Mawna Fashions Ltd

Tepirbari, Sreepur, Gazipur
(24.248209N, 90.42759E)

10th February 2015

Observations

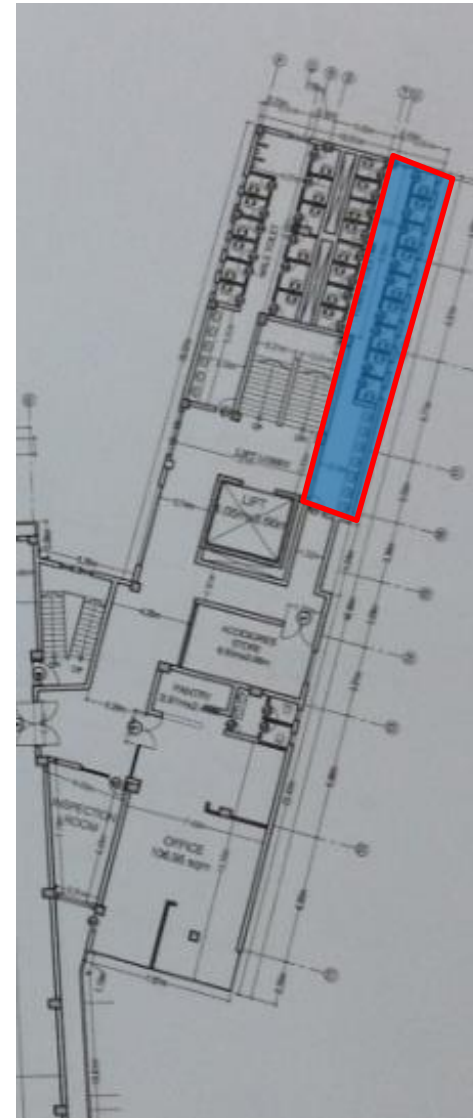
An additional space for functions mentioned in the subject is being constructed on the roof top with additional columns and slabs. On the North-East portion of the new construction Building, a cantilever slab of 8'-4" span was planned. The detailed design drawings supplied to us during the factory visit, showed that the reinforcement details were deficient. Also, an additional problem arose, which is that some of the extended columns has already been cast and hence the beams in the North-South direction of the Easternmost portion of the Building supporting this cantilever slab could not be continued through to the edge.

Letter on file outlining a noted rebar deficiency onsite and an verbal remedial action agreed.

Calculation of the additional or revised reinforcements was done at site and on-site remedy including limiting the cantilever to 7'-3" has been provided and explained orally.

6th floor plan

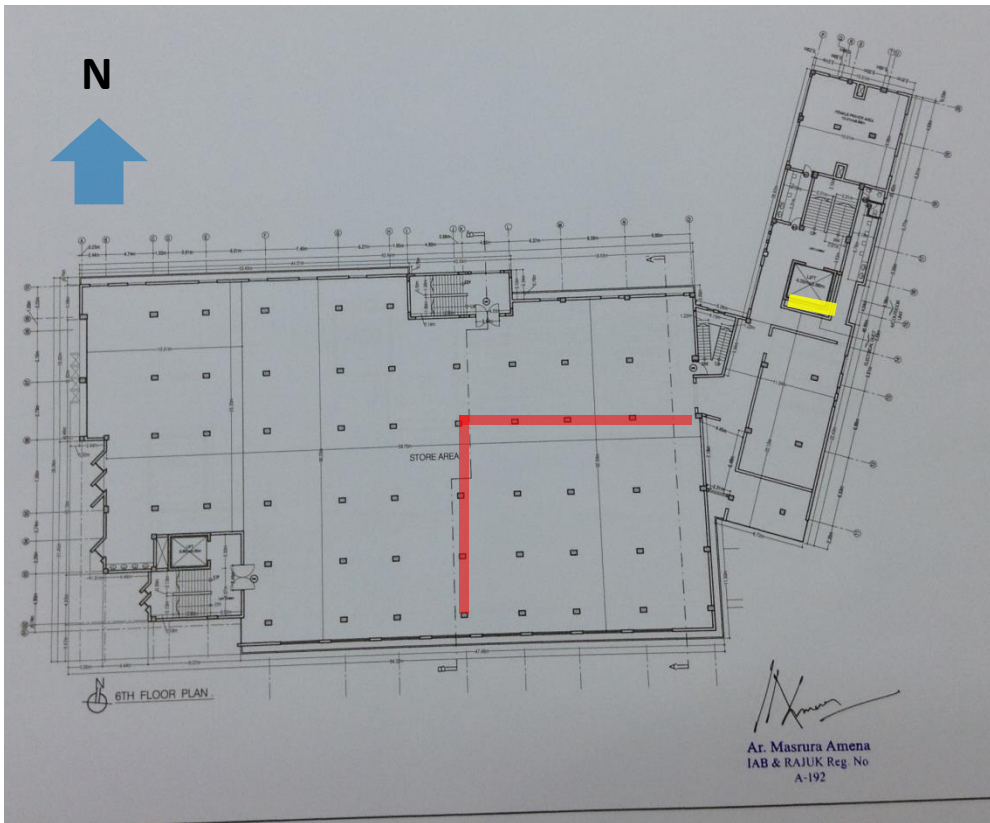
Minor differences between layout drawings and as-built

Walls are not shown in the architectural drawing

Full opening is only on 6th floor and half opening on all other floors

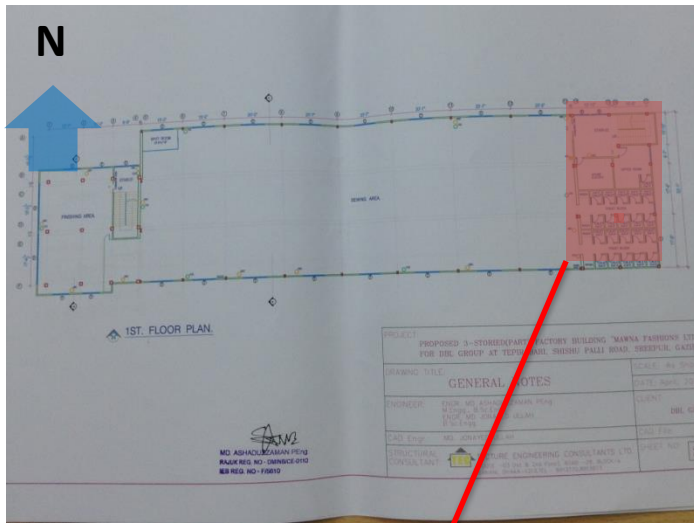
Heavily loaded columns

Toilet built up in the marked area

Heavily loaded column

Non-Engineered Roof structure lack of longitudinal bracing on the upper floor

Item No.	Observation	Recommended Action Plan	Recommended Timeline
5	Building 2 Heavy loaded column in toilet area	Factory Engineer to investigate the floor loading, and advise on any necessary alterations taking account of floor capacity and column capacity.	6-weeks
6	Building 2 Heavy loaded column in toilet area	Make any structural alterations as advised by Factory Engineer.	6-months
7	Building 2 Lack of Roof and longitudinal bracing on the upper floor	Factory Engineer to review the steel portal structure and its ability to resist lateral load. In particular the lack of effective roof bracing	6-weeks
8	Building 2 Lack of Roof and longitudinal bracing on the upper floor	Make any structural alterations as advised by the Engineer.	6-months
9	Building 2 Water tanks on the roof	Factory Engineer to investigate the roof capacity to carry the Gazi water tanks, and advise on any necessary alterations taking account of slab capacity	6-weeks

Roof Layout

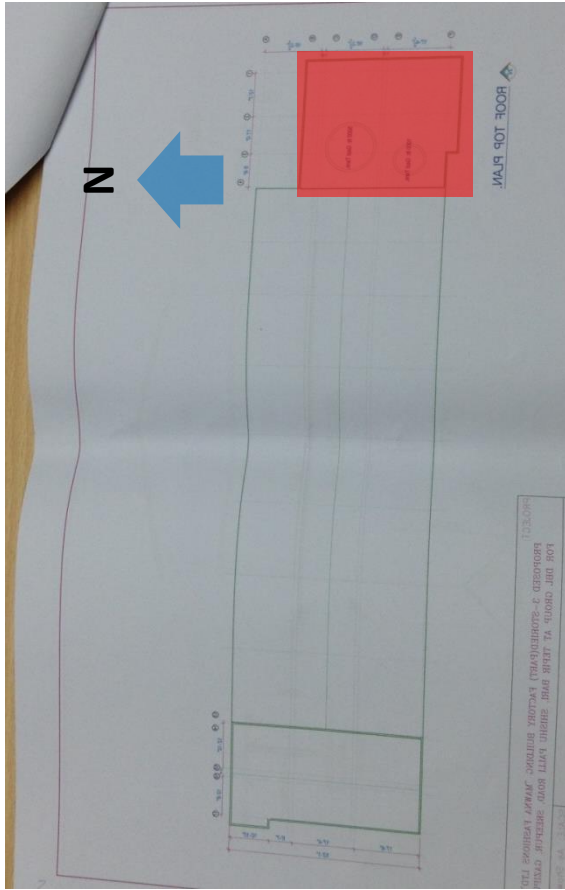
Missing roof bracings

Lack of bracings on the metal roof

Position of the water tanks

Water Tanks on the roof

10	Building 2 Water tanks on the roof	Make any structural alterations as advised by the Engineer.	6-months
